CITY OF ST. AUGUSTINE HISTORIC ARCHITECTURAL REVIEW BOARD

A G E N D A

THURSDAY, MARCH 21, 2024 - 1:00 PM

56 CARRERA STREET
REVISED EXTERIOR ELEVATIONS

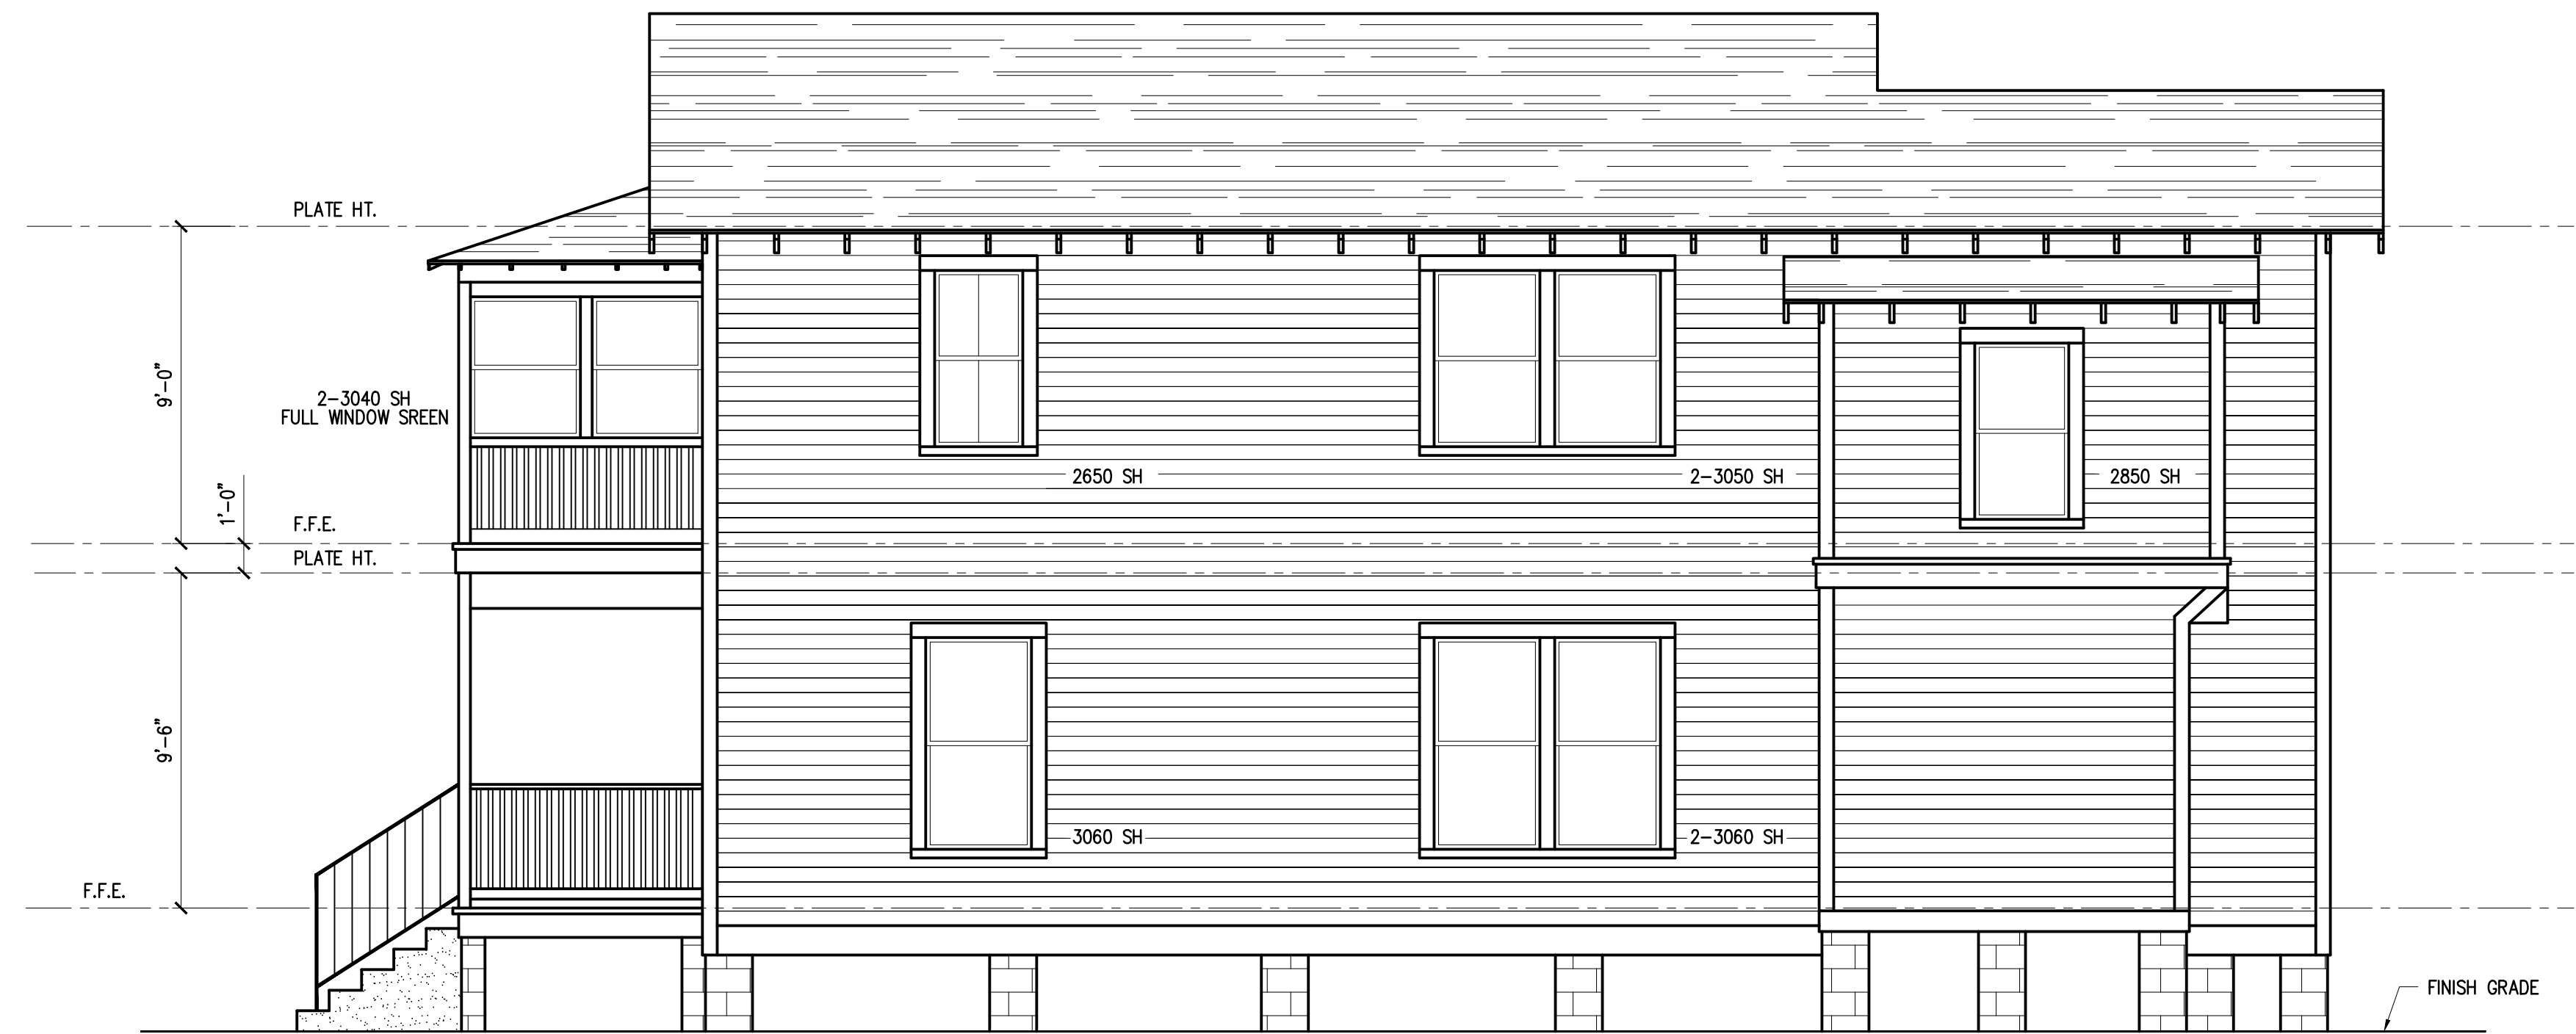
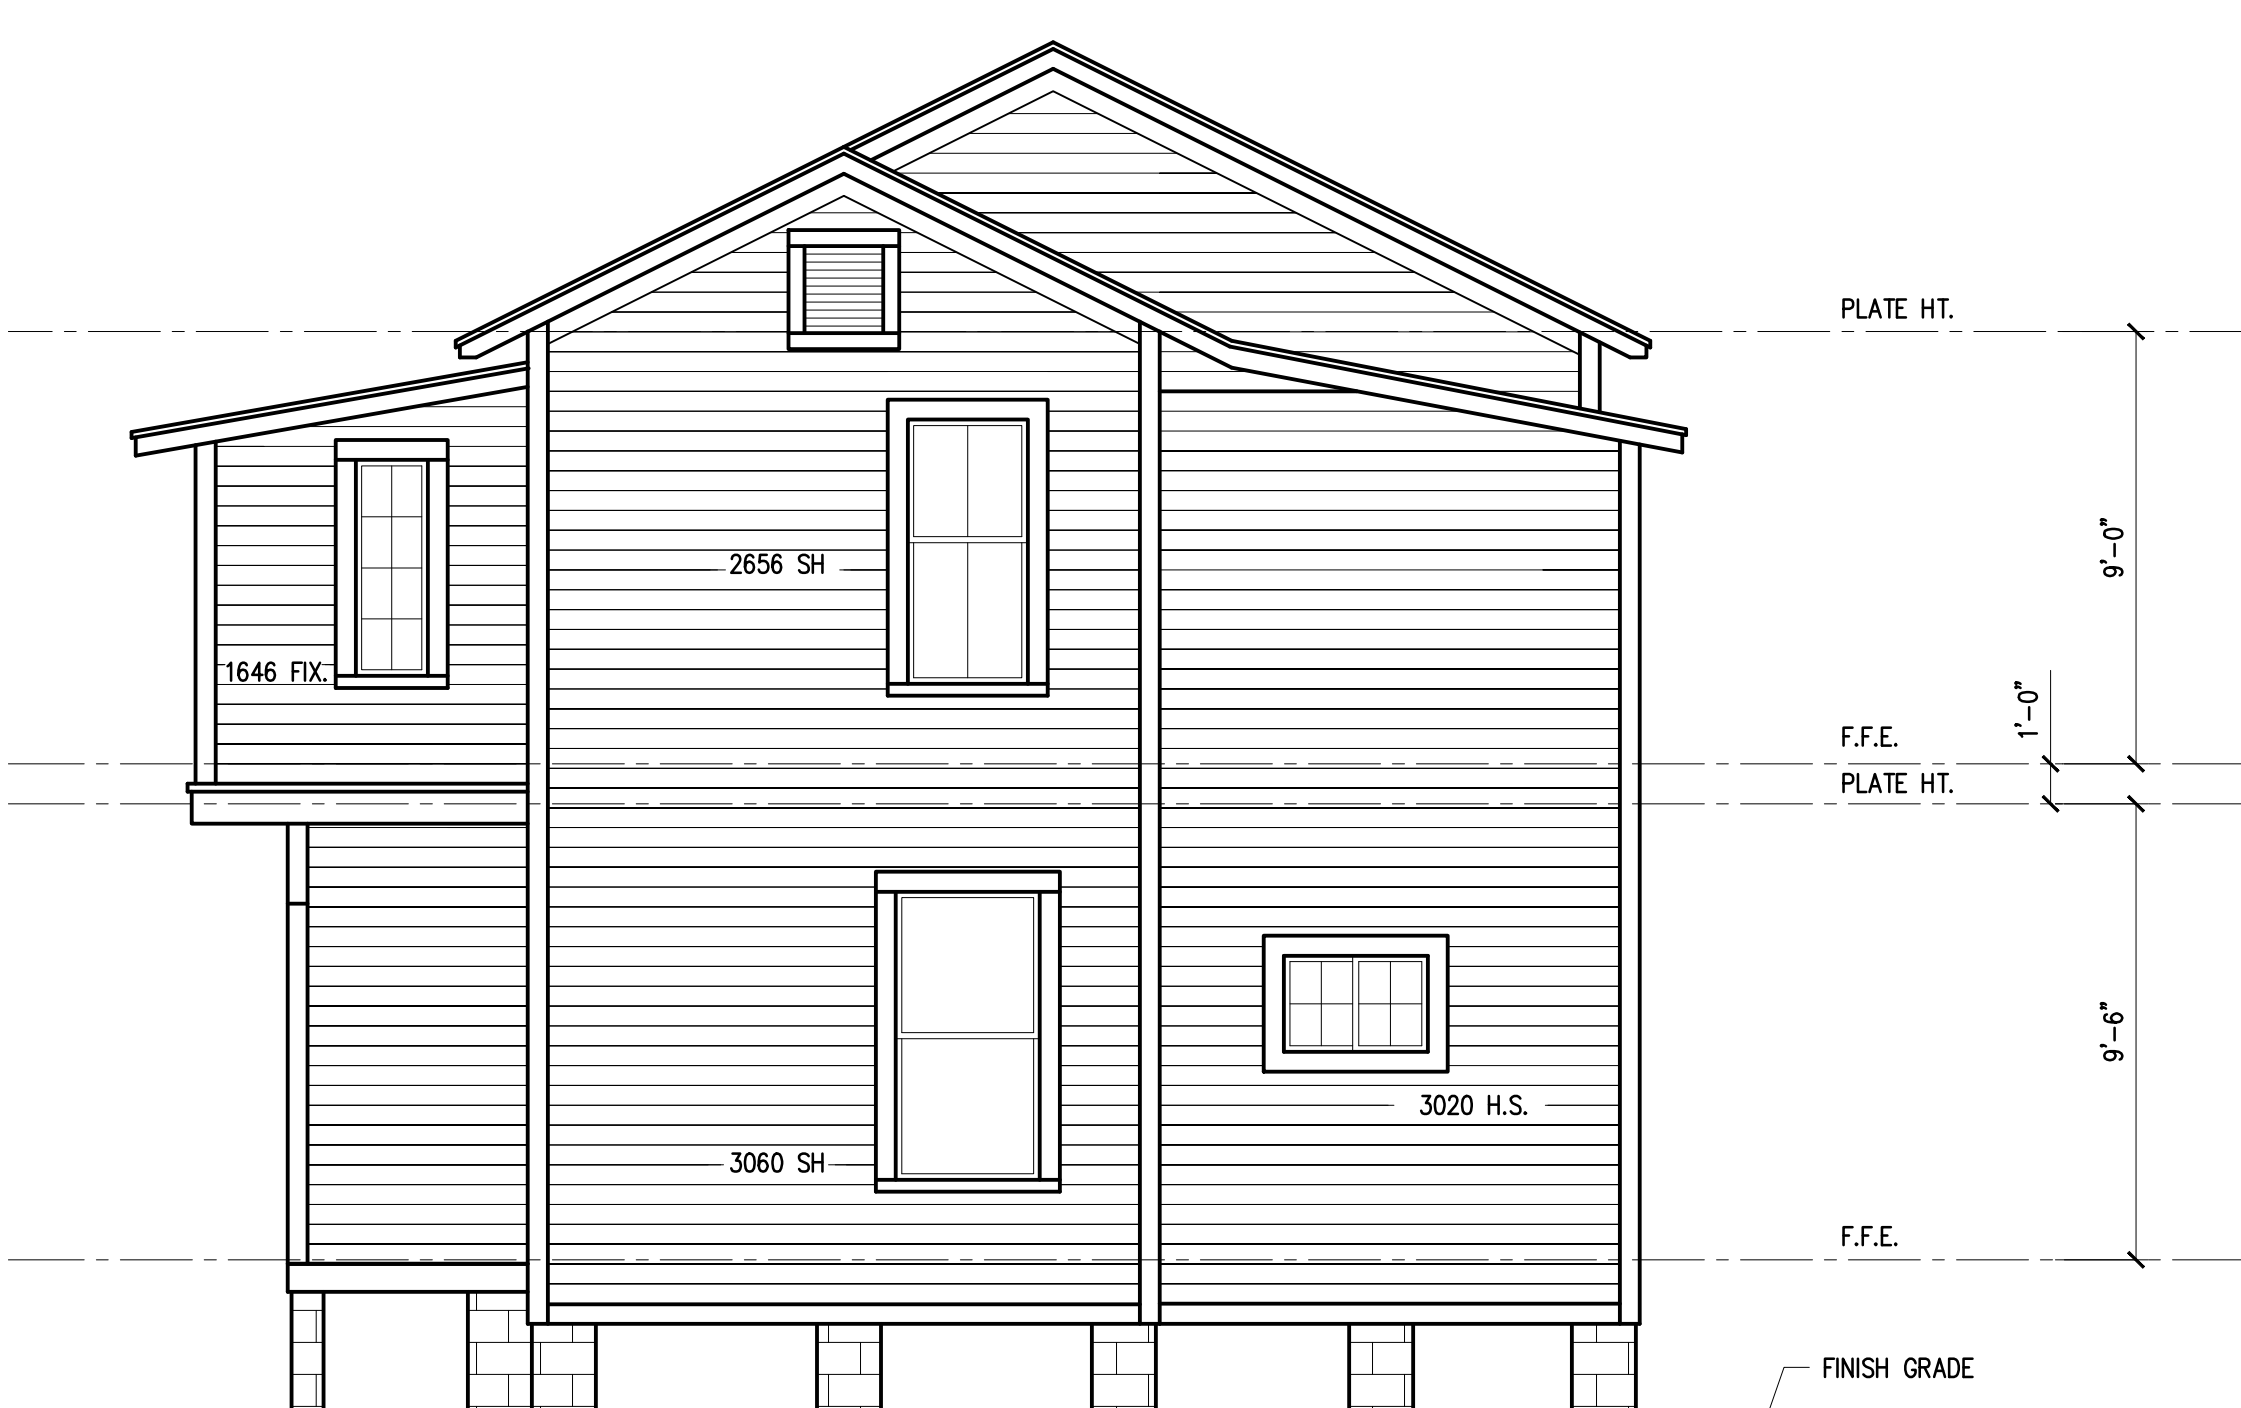
1. Are these replacing all the windows that have been replaced inappropriately? Each window being changed out for this window should be marked on the plans you submitted earlier this month.
2. This is a vinyl-clad replacement window: does it solve the concerns the Board had that the standard vinyl replacement windows sit proud of the exterior wall rather than inset like wood windows? The photos you provided don't show the windows installed, so it is difficult to determine how they will look on the structure.
3. Are you proposing any muntin pattern? I know there was discussion that 1/1 windows may be most compatible in this case. Just want to confirm this since it's not clearly noted on the plans or your e-mail below.

- clearly marked plans with the following:
 - highlight the windows you are proposing to replace with the Anderson clad windows, if you're not replacing all the windows, give a clear reason why
 - note existing wood windows that are staying as-is
 - mark on the plans that the front doors are being restored to the appropriate sizes with the original doors (if that is what you're proposing).
- the window specifications including a manufacturer's photo of what they will look like installed from the exterior. In this case, the installation drawings would also be helpful.

I've attached the latest elevation drawings you submitted so you can mark them up accordingly. If you can provide this, along with the specifications and installation examples, then hopefully the Board will provide a final answer at the next meeting if we determine the replacements are not close enough for us to administratively approve. With a clear scope of work, we will be able to administratively approve restoring the front doors.

Included is a picture of the windows.

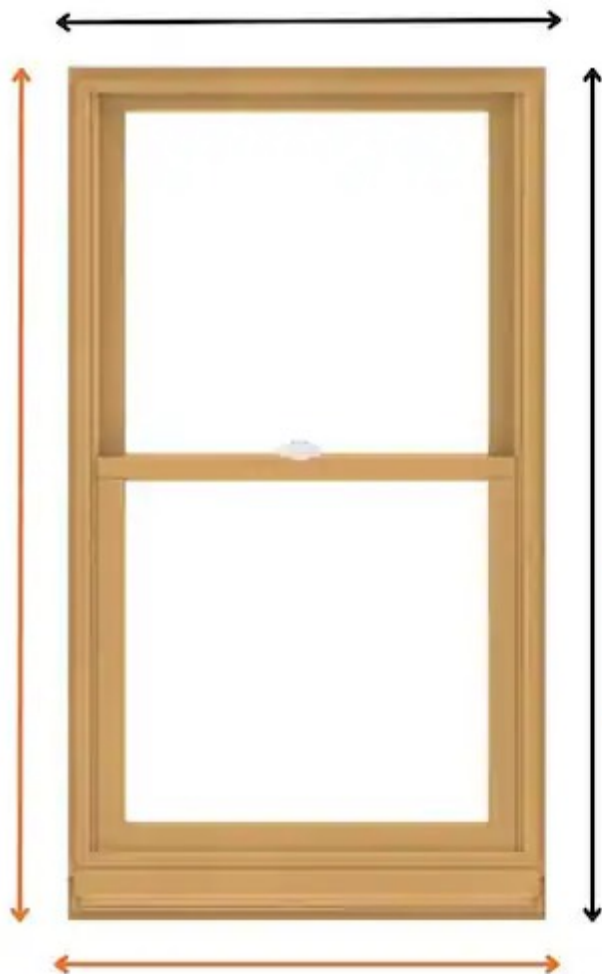
Anderson 400 series white clad wood. And we will have a screen made to go over the front of the window. This is a paintable or stainable window.
